Subject: Municipal Solid Waste – Travis County
Austin Community Landfill – Permit No. MSW 249C
Permit Modification Request – Final Cover and Drainage Improvements

PERMIT MODIFICATION REQUEST
Permit No. MSW- 249C

Final Cover and Drainage Improvements

MODIFICATION TO
MUNICIPAL SOLID WASTE PERMIT No. 249C
AUSTIN COMMUNITY LANDFILL

PROJECT NO. 1000
 CLIENT: WASTE MANAGEMENT OF TEXAS, INC.
 PROJECT: EAST LANDFILL
 DRAWING: DRAINAGE PLAN
 SHEET NO. 8-1B

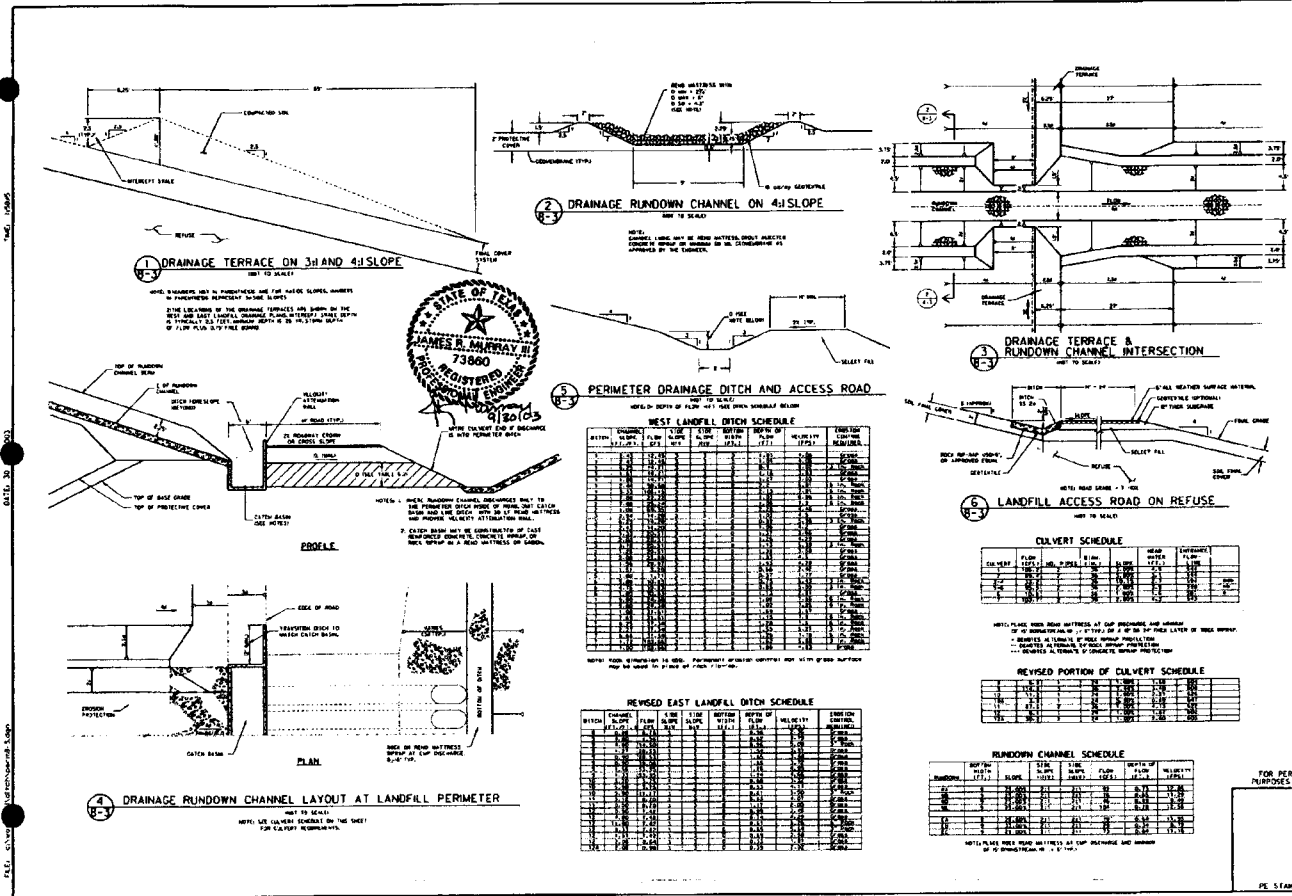
- 3) The revision of the perimeter drainage channels along the southern and eastern perimeters of the eastern waste hill to conform to the physical of the final grades.

- 5) The revision of culvert 6 to conform to the revised Central Channel South Pond Structure described in Item No. 4.
 - 6) Added culverts 10A and 12A.

DATE: NOVEMBER 2002
 PROJECT NO: 020
 DRAWING NO: 8-3
 SHEET NO: 8-3

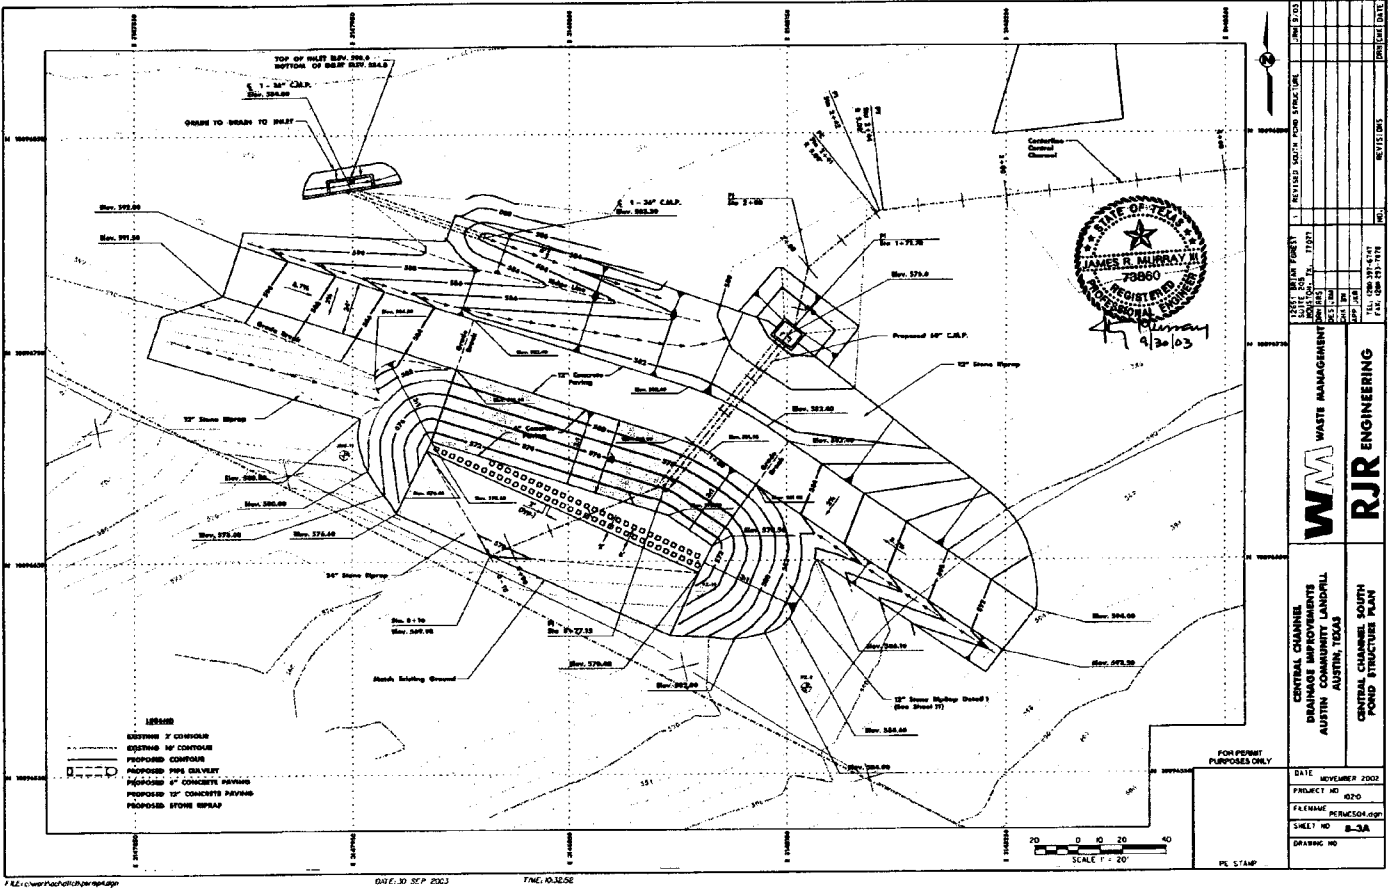
Section	Title	Description
Revision of Appendix 2.3 (text and calculations)	Post-Development Drainage Calculations	Revision of the text. Revision of the calculations for drainage terraces, perimeter ditches, rundown channels, and culverts.
Revision of Attachment 1-B (figure)	East Landfill Final Contour	Revision of final contours, perimeter ditches, interceptor berms, and rundown channels.
Revision of Attachment 8-1B (figure)	East Landfill Drainage Plan	Revision of final contours, perimeter ditches, interceptor berms, rundown channels, and sub-drainage areas.
Revision of Attachment 8-3 (figure)	Surface Water Management Details	Addition of culverts 10A and 12A, revision of culvert and ditch schedule, and revision of Drainage Terrace Detail.
Revision of Attachment 8-3A (figure)	Central Channel South Pond Structure Plan	Revision of a Central Channel South Pond Structure Plan and Culvert 6.
Revision of Attachment 8-3B (figure)	Central Channel South Pond Structure Profile	Revision of a Central Channel South Pond Structure Profile.

CENTRAL CHANNEL SOUTH POND STRUCTURE PROFILE
(NOT TO SCALE)

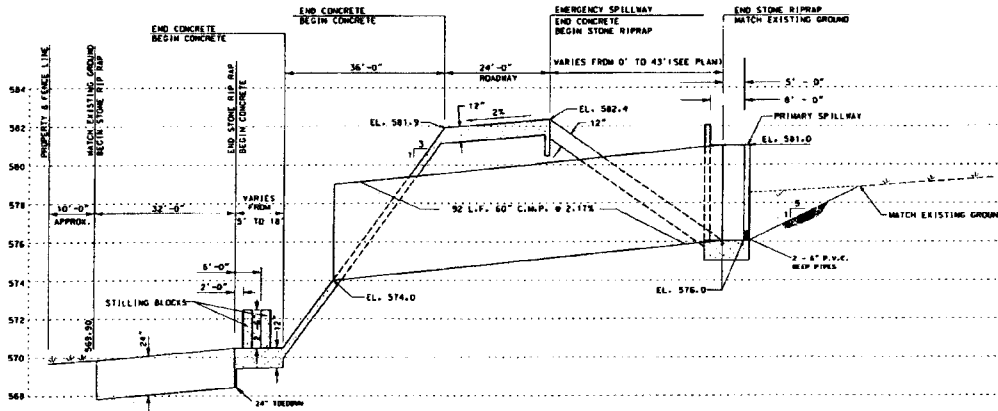
- 4) The revision of Central Channel South Pond Structure to incorporate a 60-inch corrugated metal pipe culvert and wall type weir acting as the primary spillway and a secondary spillways as a roadway weir structure. The structure will allow for storm-water storage behind the wall with dewatering provided from two six-inch pipes located at the base of the wall. A combination of concrete stilling blocks, concrete riprap, and 24 inch thick stone riprap have been included to protect the downstream receiving channel from erosion.

RJR ENGINEERING		AUSTIN COMMUNITY LANDFILL AUSTIN, TEXAS	
EAST LAGOON FINAL CONTOUR PLAN		DATE: 2-25-02 PROJECT NO: DRAWING NO: 9-2 SHEET NO: ATTACHMENT:

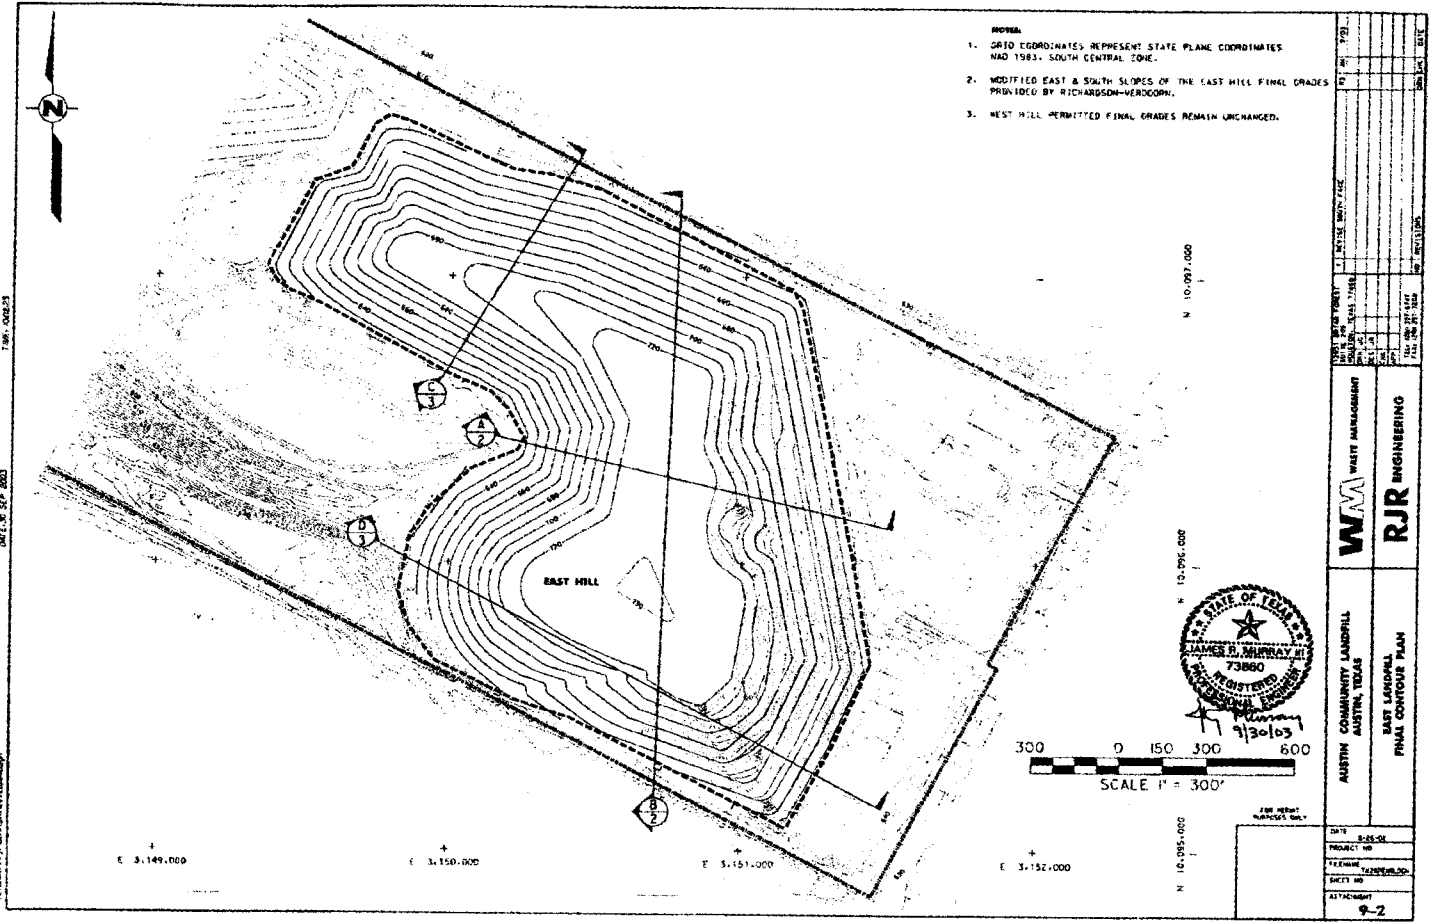
- 1) The revision of final grades on the south face of the easternmost waste hill to change the direction and location of an access way onto the top slopes of the hill.

- NOTES:**
1. GRID COORDINATES REPRESENT STATE PLANE COORDINATES NAD 1983, SOUTH CENTRAL ZONE.
 2. MODIFIED EAST & SOUTH SLOPES OF THE EAST HILL FINAL GRADES PROVIDED BY RICHARDSON-VERDOORN.
 3. WEST HILL PERMITTED FINAL GRADES REMAIN UNCHANGED.

DATE	3-26-02
PROJECT NO.	
FILE NAME	WASTE MANAGEMENT
SHEET NO.	2 OF 3
SPRING NO.	
DATE	9/30/03
PROJECT	AUSTIN COMMUNITY LANDFILL
LOCATION	AUSTIN, TEXAS
SECTION	CROSS-SECTIONS "A" & "B"
ENGINEER	RJR ENGINEERING
DATE	
REVISIONS

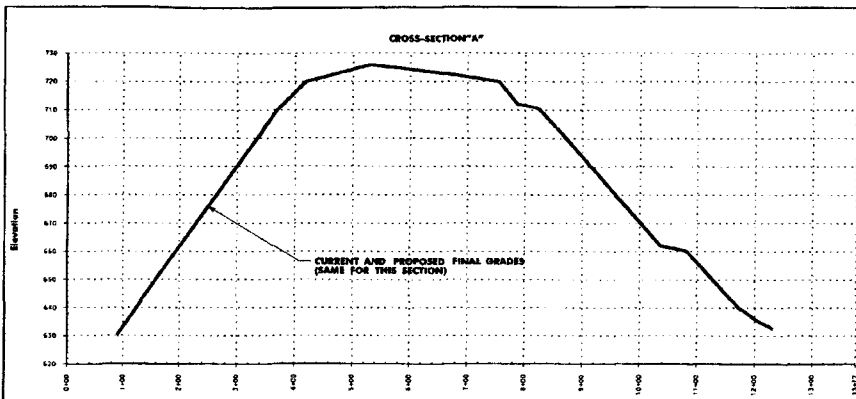
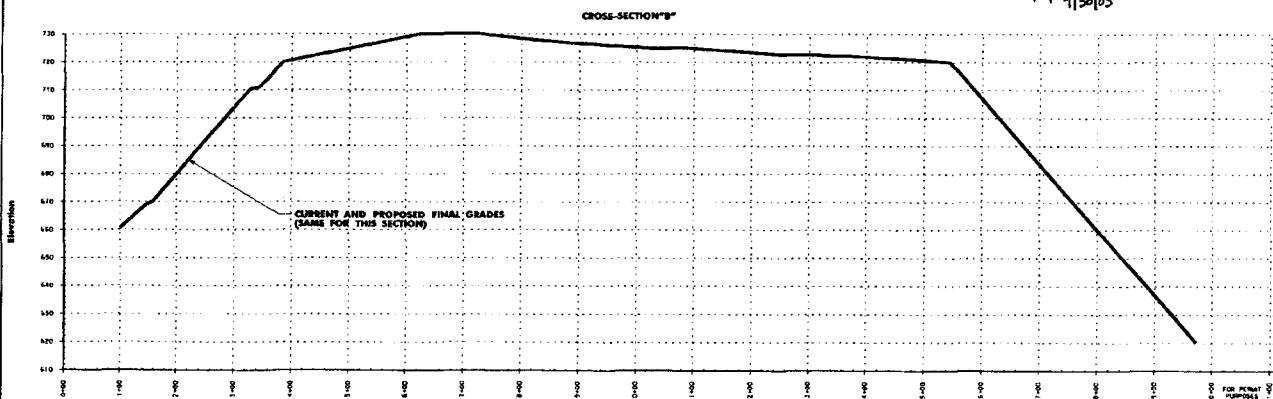
- This revision resulted in a net loss of landfill capacity of 1,550 cubic yards of permitted airspace.
- 2) The revision of the system of drainage rundown channels and terraces on the eastern waste hill to conform to the final grades as revised on the south face of the easternmost hill with this submittal and as revised elsewhere on the easternmost hill in previous TCEQ permit modifications that did not already address these features.

VOLUMES:
CUT = 5,030 CY
FILL = 3,480 CY
NET = 1,550 CY DECREASE IN CAPACITY

DATE: 8-28-02	DATE: 8-28-02
PROJECT NO:	PROJECT NO:
FILENAME: TMS\TJFA019637.dgn	FILENAME: TMS\TJFA019637.dgn
SHEET NO:	SHEET NO:
DRAWING NO:	DRAWING NO:
3 OF 3	3 OF 3

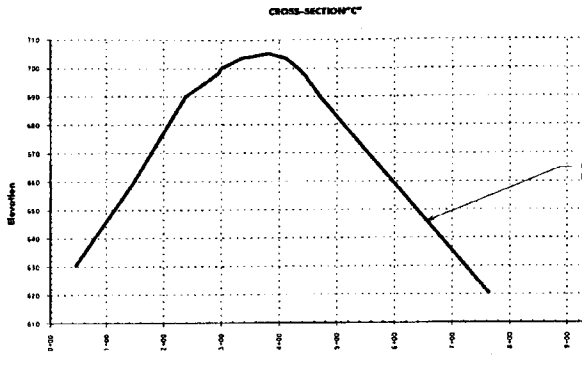
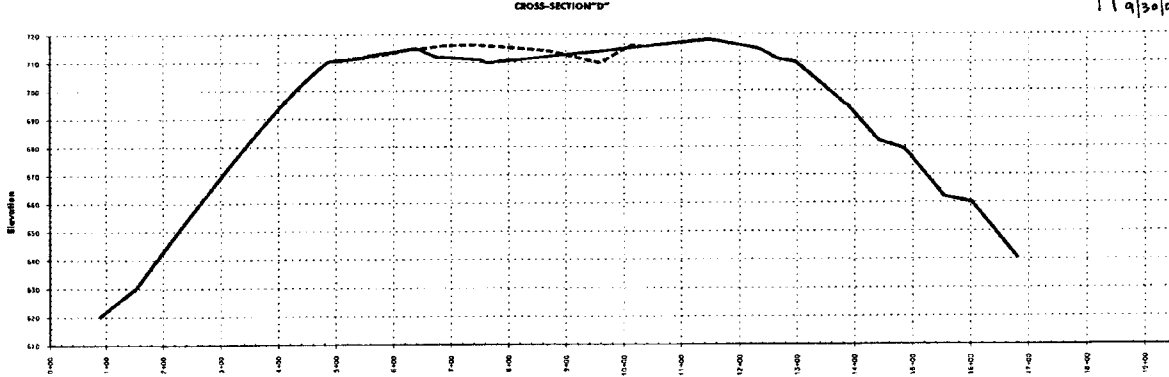
VOLUMES:
CUT = 5.030 CY
FILL = 3.480 CY
NET = 1.550 CY DECREASE IN CAPACITY
